Our Ref: HBC\Planning\RA_v1.0

Your Ref: APP/17/00224

APP/17/00224 - Listed Building Consent for the construction of a four bedroom detached dwelling and detached triple garage and access from Edward Gardens, with associated soft and hard landscaping. The Manor, Edward Gardens, Havant, PO9 3JJ

The arched entrance depicting structural deterioration.

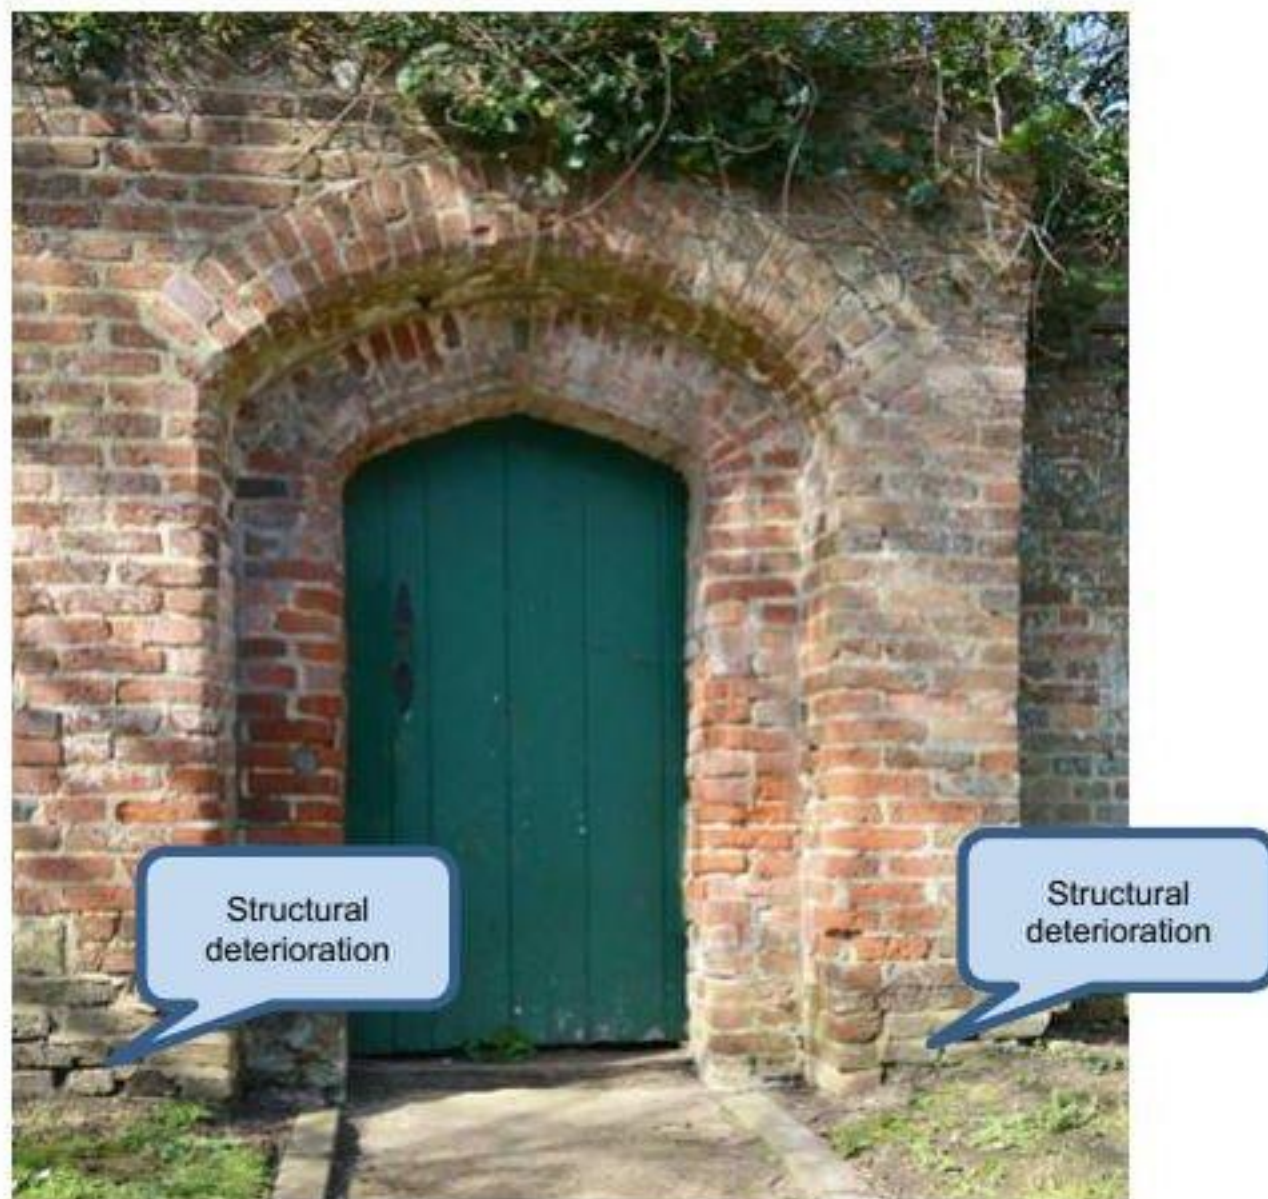
Can you please advise if any formal risk assessment has been carried out? The risk posed to potentially damaging this heritage asset that even piling may inflict upon the Tudor Wall and arched entrance is unquantified, let alone identified. Despite the assertion included in the Heritage Statement that the "sixteenth century boundary wall and Tudor arched entrance would be retained and repaired where necessary" what is the level of risk to this heritage asset? I recommend the risk factors take account of:

- Vibrations from a piling hammer should be calculated to forecast, through analysis, what is the likely impact of fracturing the original Tudor slate/brick foundations fabric. Traffic past this Tudor Wall on the Pavilion side is restricted by the Bidbury Mead height bar. Only light cars and vans are permitted to access the Bedhampton Bowls Club and tennis courts. Even HBC's Massey Ferguson grass mowing tractor deliberately detours via the playing fields and keeps well clear of the Tudor Wall!
- The arched entrance needing urgent repair. This became apparent when making preparations for the Mayor's visit to The Manor to open the final Coffee Morning in support of The Charitable Trust. This was several years ago and a recommendation was made at that time not to attempt to open the gate owing to severe degradation;
